Our ref: 048038-LTR-15

April 12, 2023

Request for Operating and Monitoring Plan Amendment New Richmond Closed Landfill New Richmond. Wisconsin

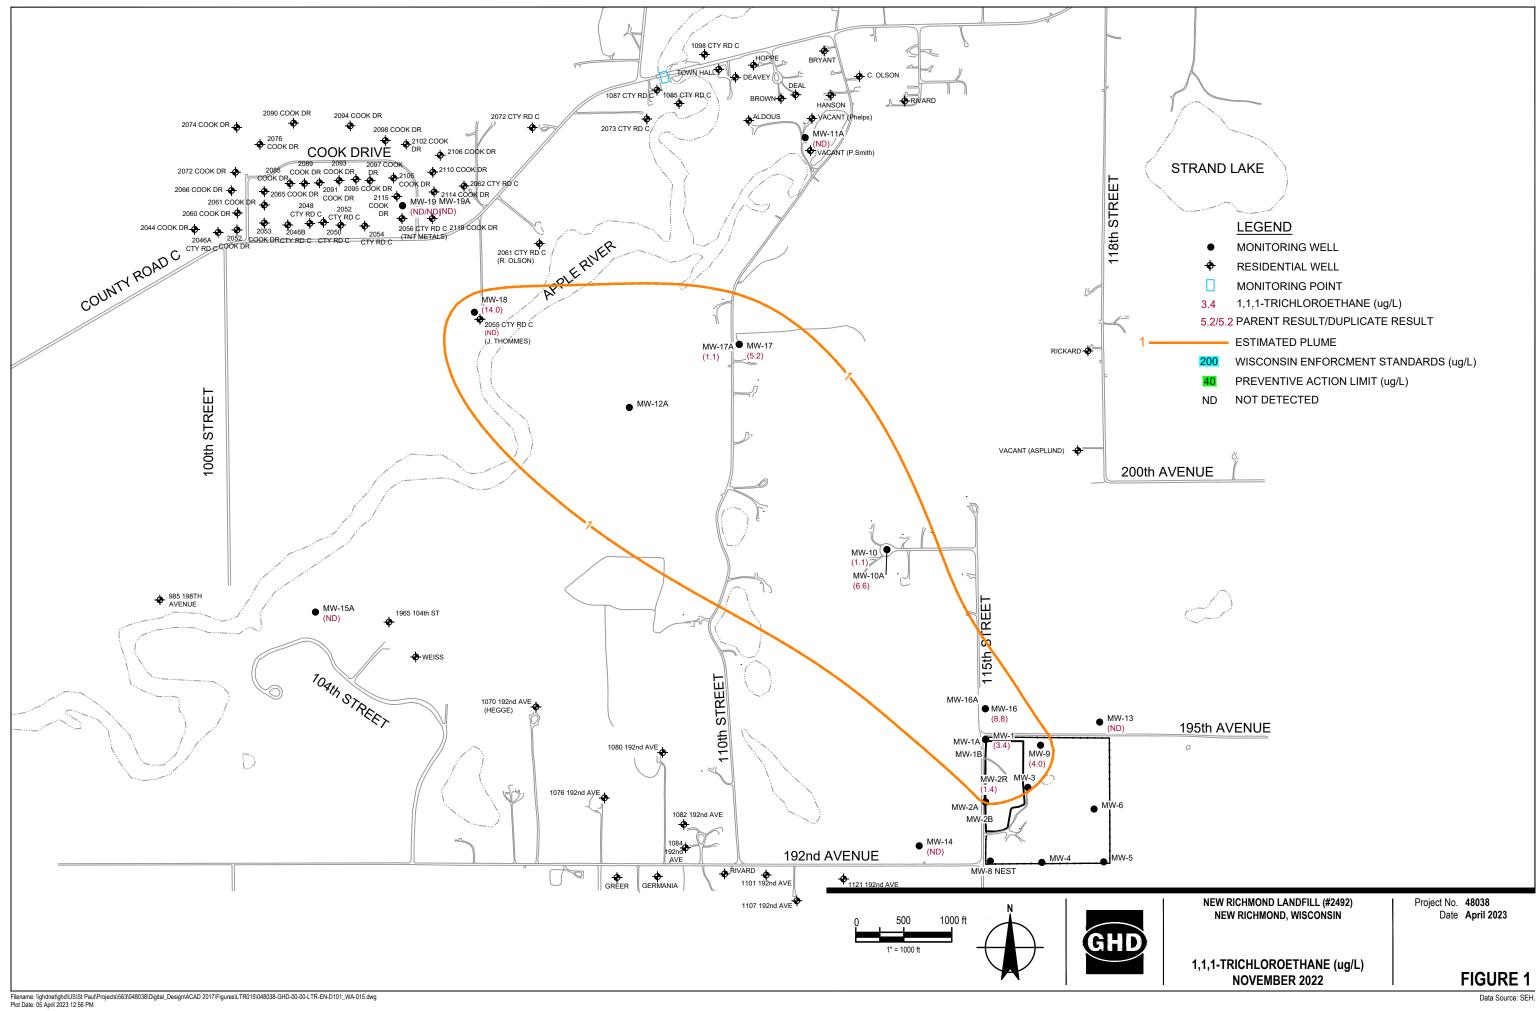
- 1. Remove MW4, MW5, MW6, MW8, and MW8A from the groundwater level monitoring and groundwater sampling schedule. These five wells are located upgradient of the Site and of which only MW6 is currently on the groundwater sampling schedule. However, due a broken casing, MW6 has not been sampled since 2017. Landfill associated VOCs have not been detected in any of these wells in the last 15 years. Once removed from the Monitoring Plan, GHD recommends that these five wells are plugged and abandoned using materials and methods as prescribed in NR 812.26, Wis. Adm. Code. All five wells are located on the City of New Richmond property. The City is currently developing this area into a recreational park.

- 2. Remove MW11A, MW13, MW13A, MW14, MW14A, MW15, and MW15 from the groundwater level monitoring and groundwater sampling schedule. These seven wells are located side-gradient of the groundwater plume and of which only MW11A, MW13, MW14, and MW15A are currently on the groundwater sampling schedule. Landfill associated VOCs have not been detected in these wells in the last 10 years. Once removed from the Monitoring Plan, GHD recommends that these seven wells are plugged and abandoned using materials and methods as prescribed in NR 812.26, Wis. Adm. Code. All seven wells are located on private property.

- 3. Remove MW12 and MW12A from the groundwater level monitoring schedule. Currently, neither one of these two wells are on the sampling schedule. These wells are located directly downgradient of the landfill, but landfill associated VOCs have never been detected in these wells. Both wells are installed too shallow to monitor the groundwater plume downgradient of the landfill. Once removed from the Monitoring Plan, GHD recommends that these two wells are plugged and abandoned using materials and methods as prescribed in NR 812.26, Wis. Adm. Code. Both wells are located on private property.

- 5. Change the monitoring frequency of MW1, MW10, MW10A, MW16, MW16A, MW17, MW17A, MW18 from semi-annual to annual. These eight wells are currently located in the footprint of the groundwater plume and are sampled on a semi-annual basis. There has not been a Wisconsin Enforcement Standard (ES) exceedance in any of these wells since 2016, with the exception of an anomalous concentration of 1,2 Dichloroethane in MW-18 in 2021.
